Arlington Conservation Commission

Date: Thursday, February 6, 2025

DEP #091-0356: Notice of Intent: Thorndike Place (Continued from 01/16/2025).

The Conservation Commission will hold a public hearing under the Wetlands Protection Act to consider a Notice of Intent for the construction of Thorndike Place, a multifamily development on Dorothy Road in Arlington. Areas proposed to be altered include Buffer Zone to Bordering Vegetated Wetland and Bordering Land Subject to Flooding associated with Alewife Brook.

Figure 2 - Hydrograph for USGS Lexington Index Well (March - April 2024)

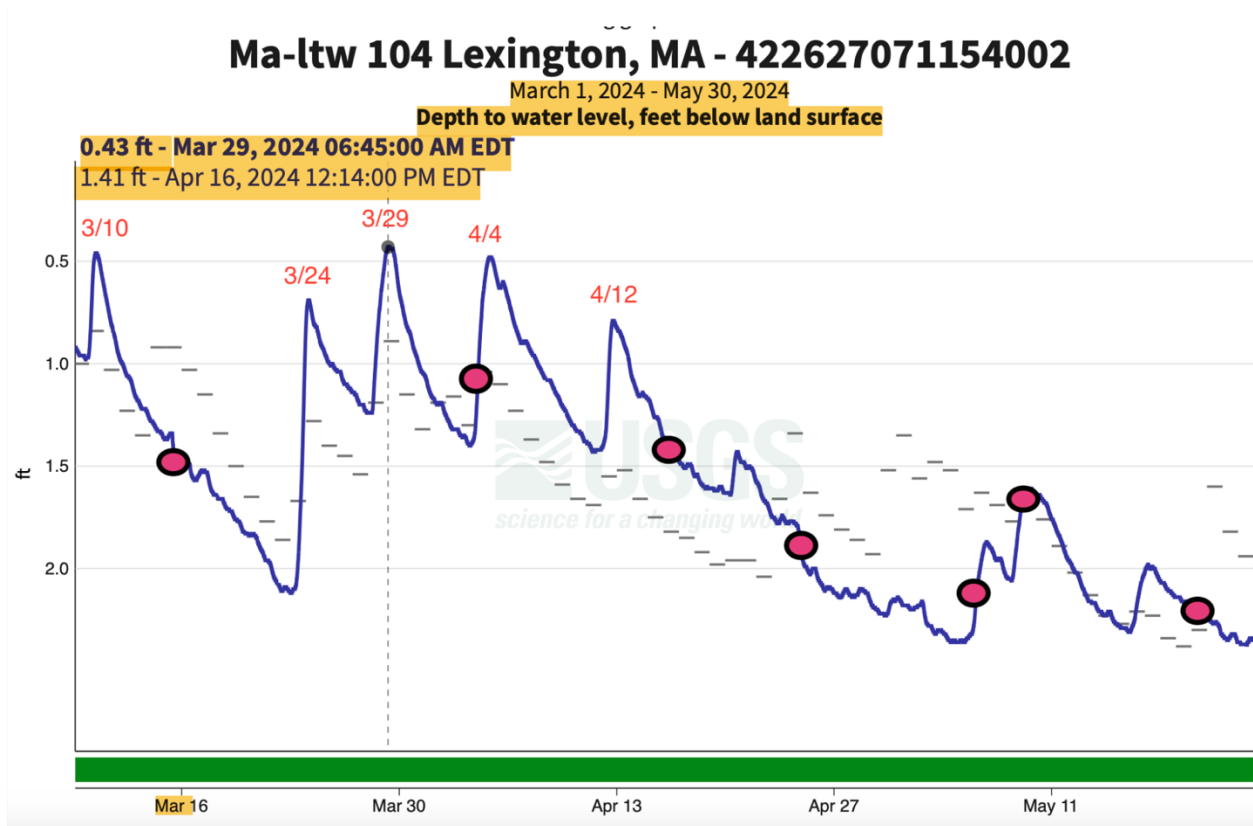
Figure 2 shows a comparison of water levels measured in a well installed by BSC at the location of TP-9 (red dots) with the USGS Lexington well hydrograph during the 2024 spring period. This comparison shows that BSC water level measurements were reported on dates that missed all of the peak levels recorded at the USGS well during the Spring 2024 period. The highest groundwater levels were observed at the USGS well on March 24, 29, and April 4. Had BSC used a continuous recorder (as I recommended in my earlier comment letters) they would have likely recorded higher levels, consistent with the USGS well).

This comparison shows that the highest water level measured by BSC was on April 1 when the USGS well was more than one foot below its peak high measurement on March 10. This suggests that the ESHGW would be at least 5.0 feet. This would be consistent with the redox level of 5.8 feet reported by Whitestone.

Figure 3 - Hydrograph for Arlington Land Trust (ALT) Monitoring Wells at Dorothy Road (March - April 2024)

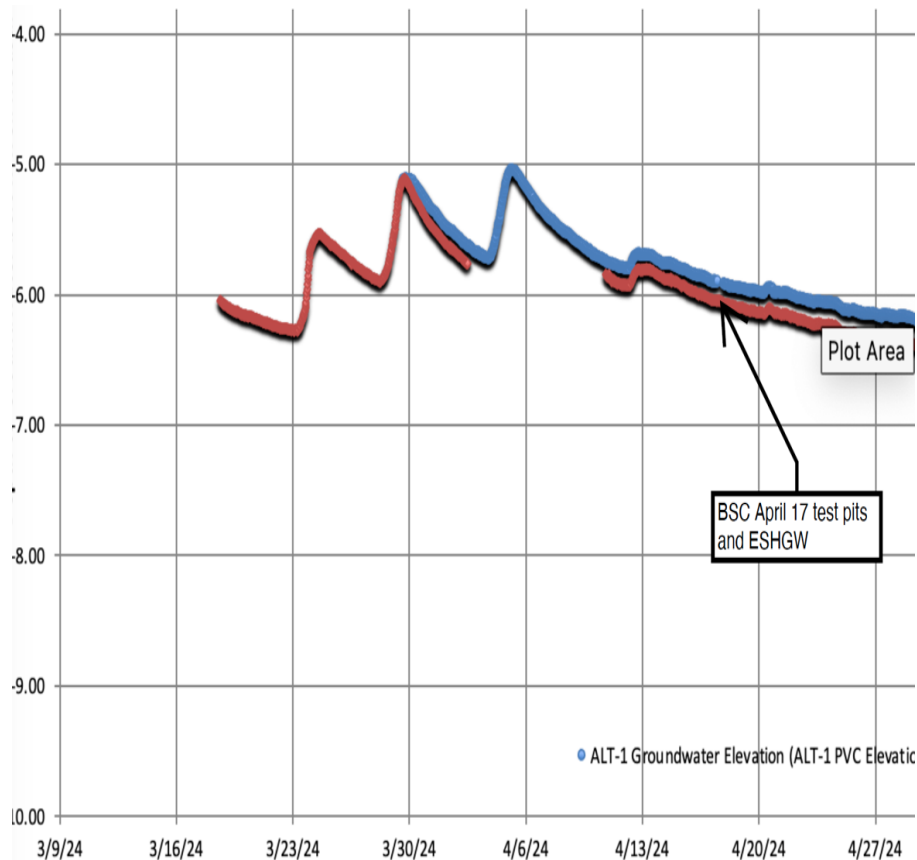
This same variance in groundwater levels is further corroborated with our own water level measurements at the Arlington Land Trust well located on Dorothy Road which showed a peak elevation on March 29, 2024 and a similar decline throughout much of April to a level of approximately 1-foot lower on April 17 when the test pits were excavated (see figure 3). This suggests that the relative groundwater level fluctuations over this period are consistent with the USGS Lexington well (which showed a 1-foot decline during this same period).

© 2023 BSC Group, Inc.
SCALE: 1" = 30'
0 15 30 60 FEET
FILE: 2340702\C\2340702-GR
DWG.:
JOB. NO: 23407.02 SHEET C-104

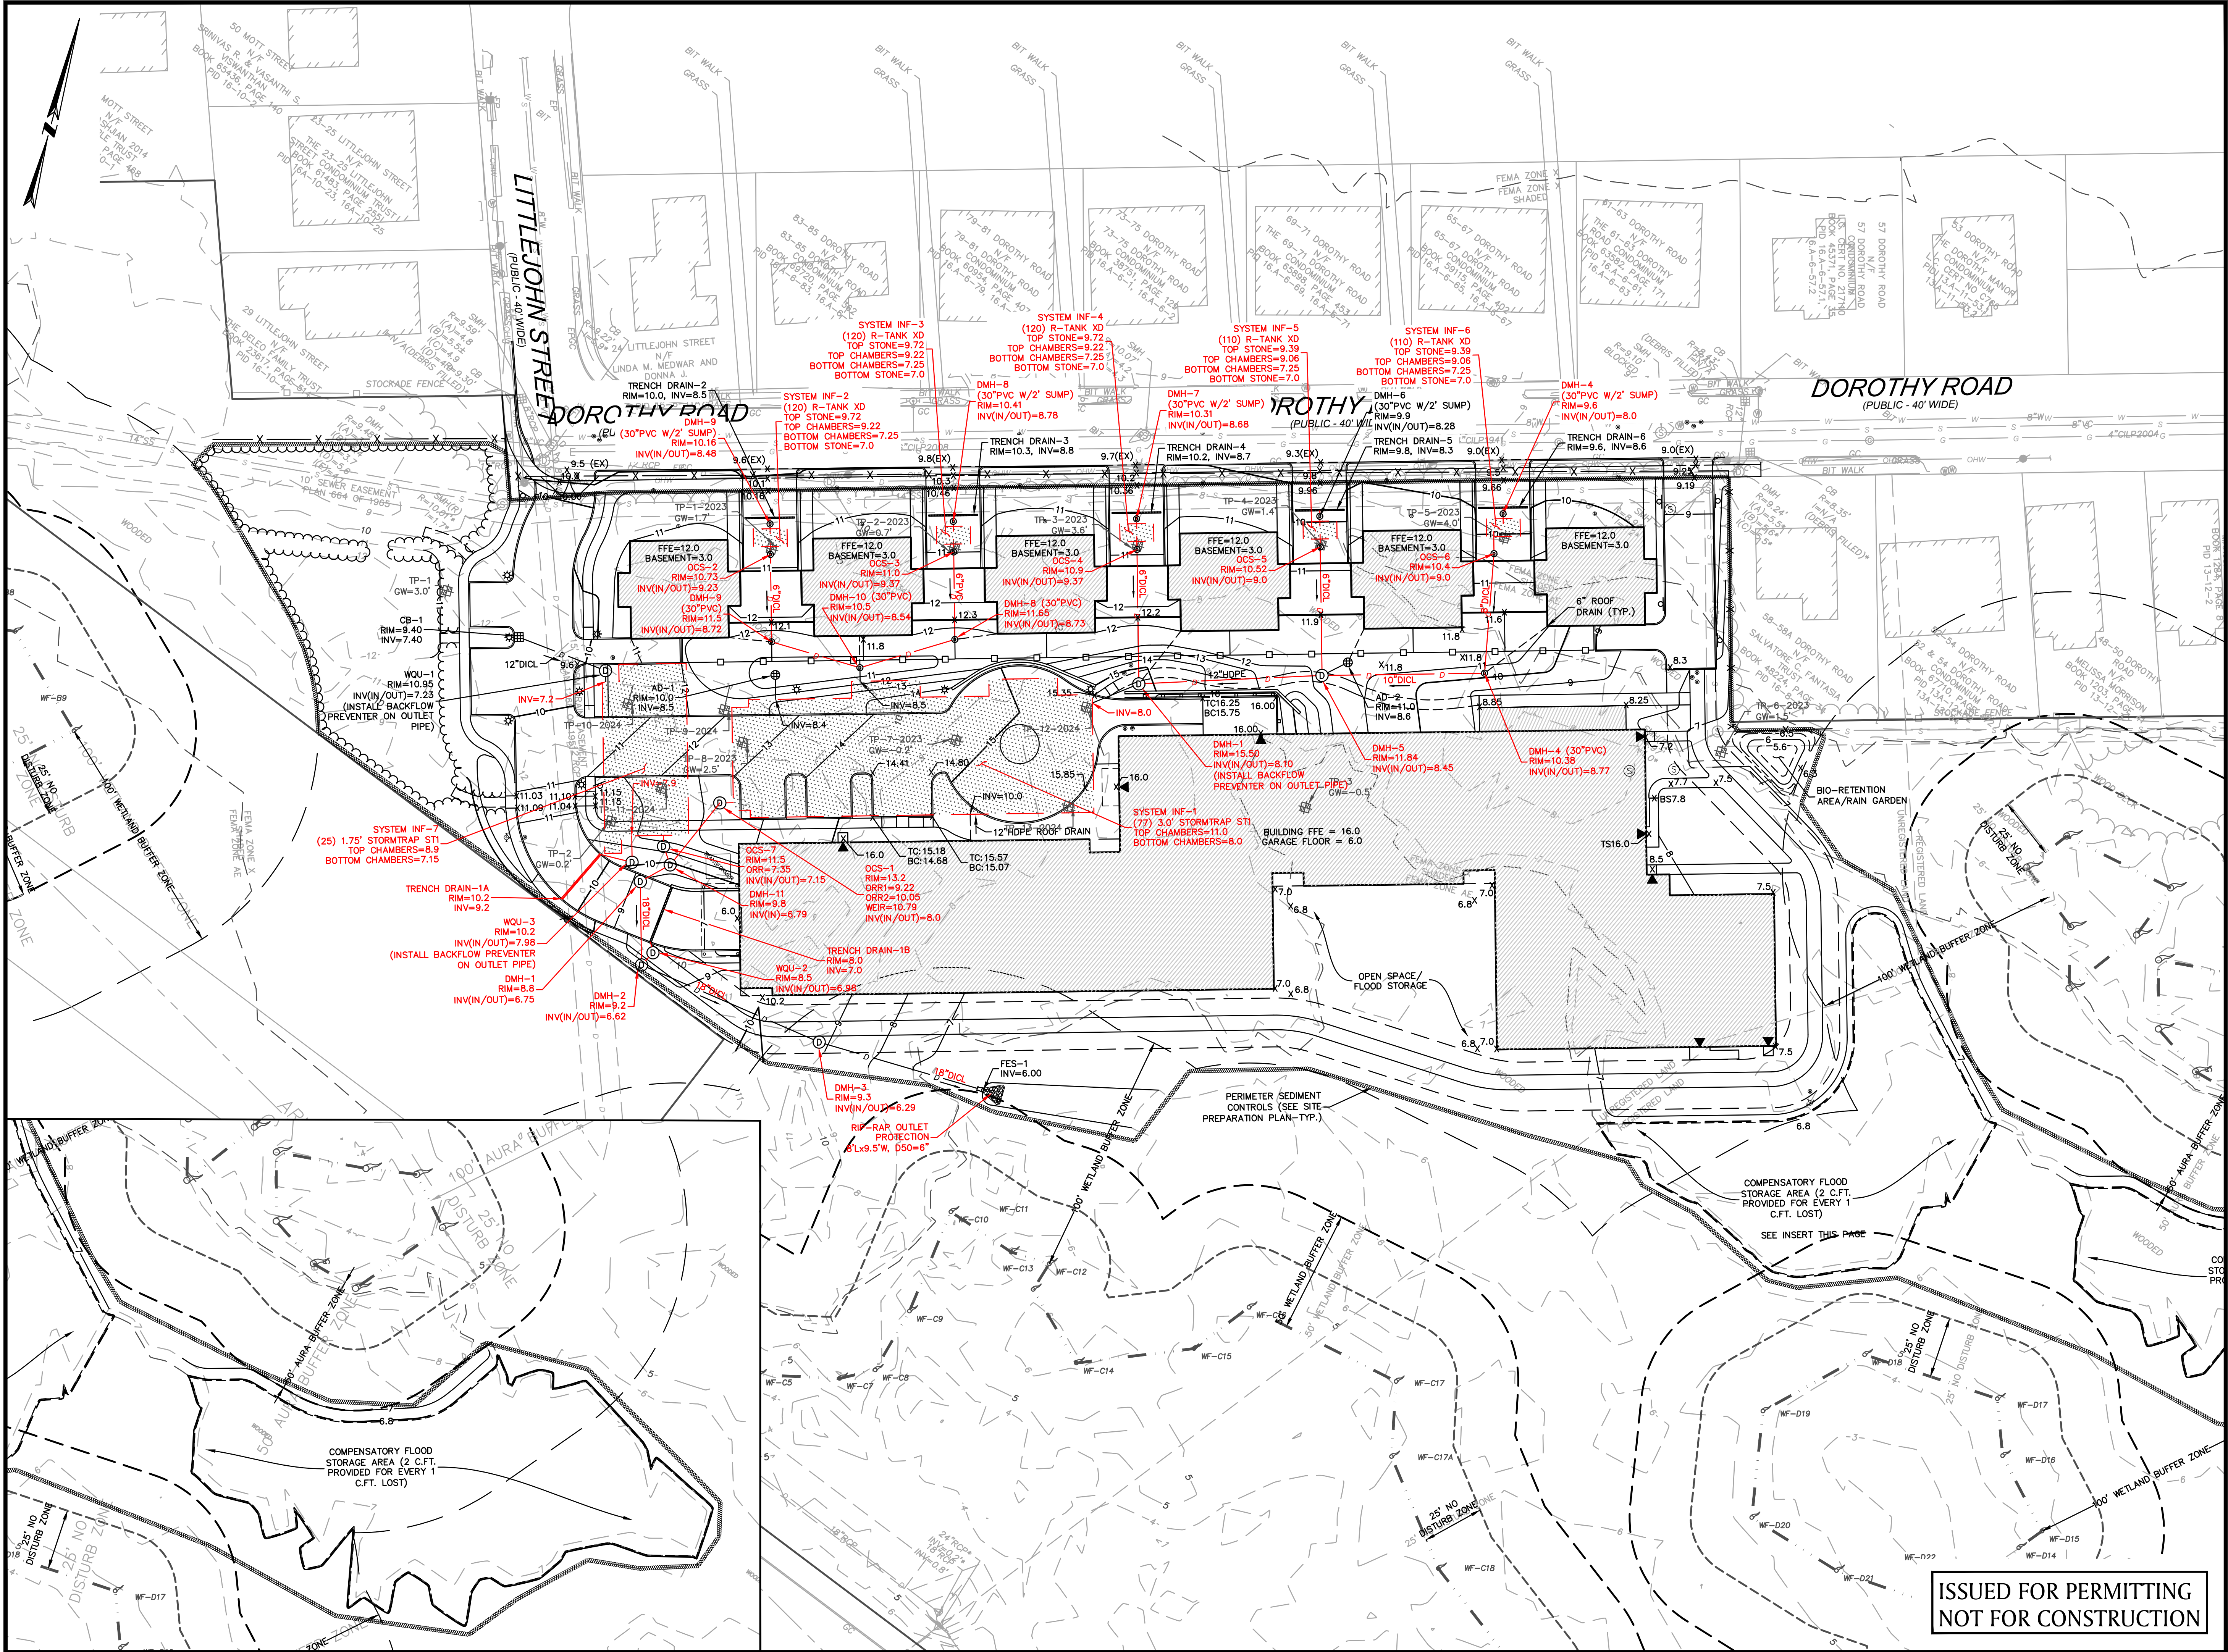
Sheet C-104 as Infiltration Systems 2-6) consists of varying numbers of R-Tank XD units with the same footprint and a bottom of stone elevation of 7.0 (i.e., 3-feet above estimated seasonal high groundwater), and designed so they maintain a minimum of 10-feet separation from any building foundation. In larger storm events, these systems will overflow to a larger underground infiltration system (Infiltration System 1). A groundwater mounding analysis of these systems has been performed utilizing the total volume infiltrated during the 100-year, 24-hour storm event resulting in an expected groundwater mound of less than 1-foot. A drawdown analysis utilizing the full volume below the lowest outlet and the Rawls Rate for silt loam per GZA's request (0.27 in/hr) has been performed demonstrating that these systems will drain in less than the required 72-hours. The mounding analysis and drawdown calculations are included in Section 6 of the attached Stormwater Report and Summary of Revised Calculations.

- b. A separate underground infiltration system, Infiltration System 7 (see attached Sheet C-104), has been located to the west of Infiltration System 1 and consists of 25 1.75-foot StormTrap chambers with a bottom elevation of 7.15 (which corresponds to 3.15-feet above ESHGW). This system collects runoff from driveway and paved areas associated with the multi-unit building. A groundwater mounding analysis of this system has been performed utilizing the total volume infiltrated during the 100-year, 24-hour storm event resulting in an expected groundwater mound of less than 3 feet. A drawdown analysis utilizing the full volume below the lowest outlet and the Rawls Rate for silt loam has been performed demonstrating that this system will drain in less than the required 72-hours (see Section 6 of the attached Stormwater Report and Summary of Revised Calculations). As part of this design, an additional trench drain has been added to the driveway entrance to the multi-unit building to collect runoff and route it into Infiltration System 7 after passing through a water quality unit.

- c. During larger storm events, both Infiltration Systems 1 and 7 overflow to a flared end section (FES-1) to the south of the multi-family building via outlet control structures that connect to a new drain manhole. This is the same discharge point as in the previous designs (see attached Sheet C-104). Please note that the two systems are not connected to each other, but overflow to the same point.

has been eliminated as well, and all roof runoff from this building is routed via roof drains to Infiltration System 1 (see attached Sheet C-104).
